SUWANNEE VALLEY RESORT

AQUATAN POOLS
OF
FLORIDA INC.

PROVISOS:

PAGE 1 OF 6
DATE 2/4/2012

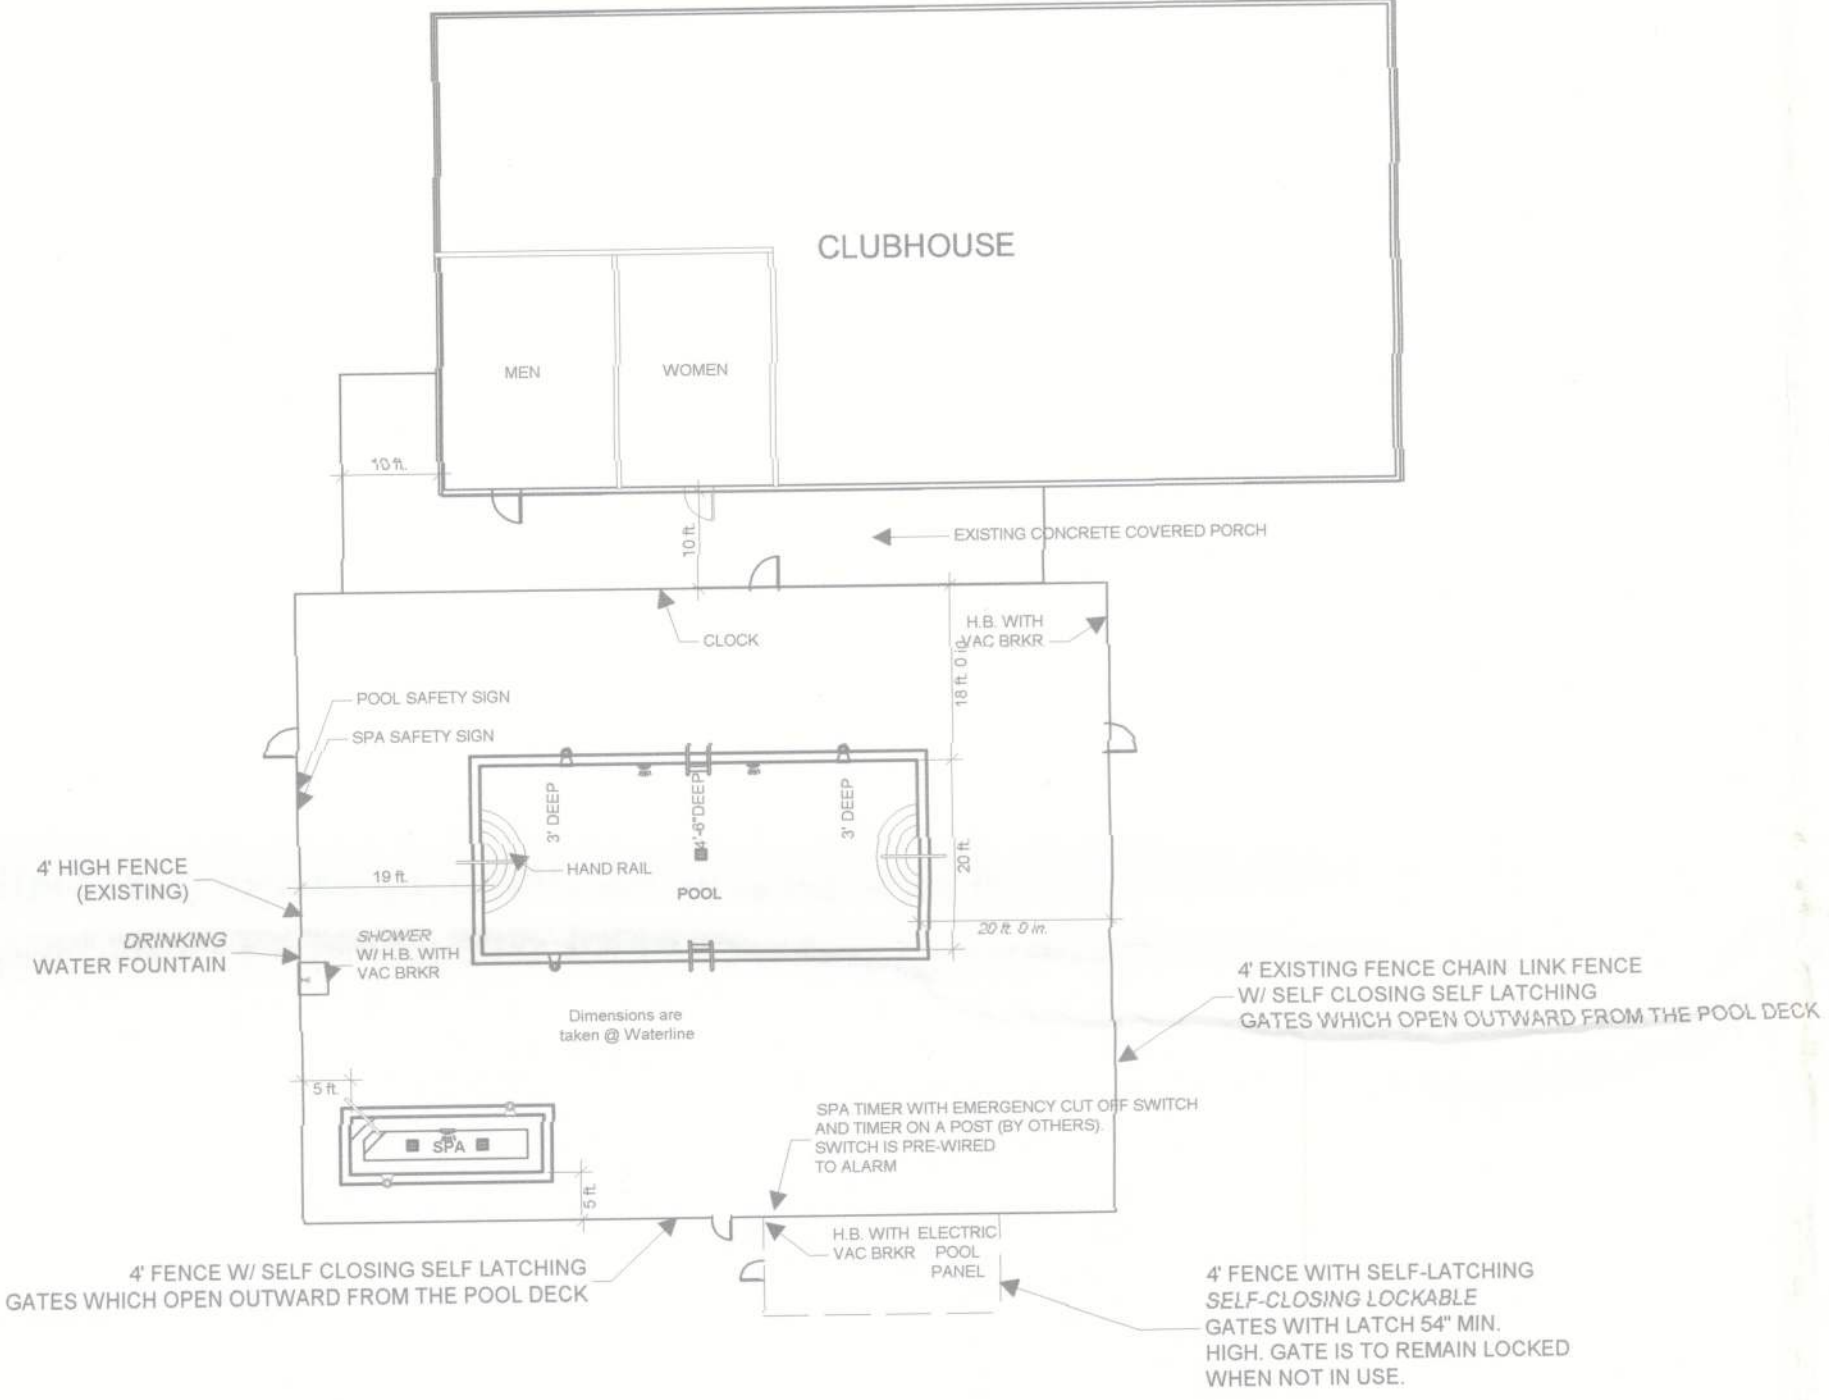
- Pool**
- 64E-9.007(8) Ensure the main drain used is the six inch line shown on the pool plumbing drawing and not the 4 inch shown in the equipment drawing.

- 64E-9.006(1)(c)1. Ensure the pool wall is vertical within 5 degrees for the first 2 1/2 feet from the top. The 12 inch wall to floor radius shall be reduced to 6 inches in the shallow areas.

- 64E-9.006(1)(d)3. Ensure the 3/4 X 2 inch tile used on the step edge is bullnose or use 2 inch tile on both the riser and tread.
 - 64E-9.006(1)(d)5. Ensure the hand rail is 28 to 40 inches above the step edges as well as above the pool deck.

- 64E-9.007(4) Ensure the filter pump can provide 150 GPM at 60 TDH or justify as to why a lesser TDH is appropriate. (See application).
 - 64E-9.007 (10)(c) Provide a hydrostatic relief valve in the pool floor if there is high ground water in the area.

- 64E-9.006 (2)(c) Ensure the pool heater is within the fenced equipment area.
 - 64E-9.006(2)(f) Ensure there is a hose bib with a vacuum breaker in or at the restrooms.

- 64E-9.006(2)(f) Ensure the chemical crocks are labeled.
- Spa**
- 64E-9.007 (9)(f) Provide an additional inlet fitting so that the flow rate through each inlet does not exceed 20 GPM.

- Provisos # 2, 3, 7, 8 and 9 above are also pertinent to the spa pool. Use the same bull nose tile on the benches
 - 64E-9.007 (13) Use a 2 1/2 inch flow meter that reads from 50% to at least 150%. The 1 1/2 inch flow meter shown on the equipment list is inappropriate.

- The pipe size on the filter pump suction is not indicated. Use a 3 inch line.
 - 64E-9.010 (6)(d) Ensure a 15 minute therapy pump timer is used.
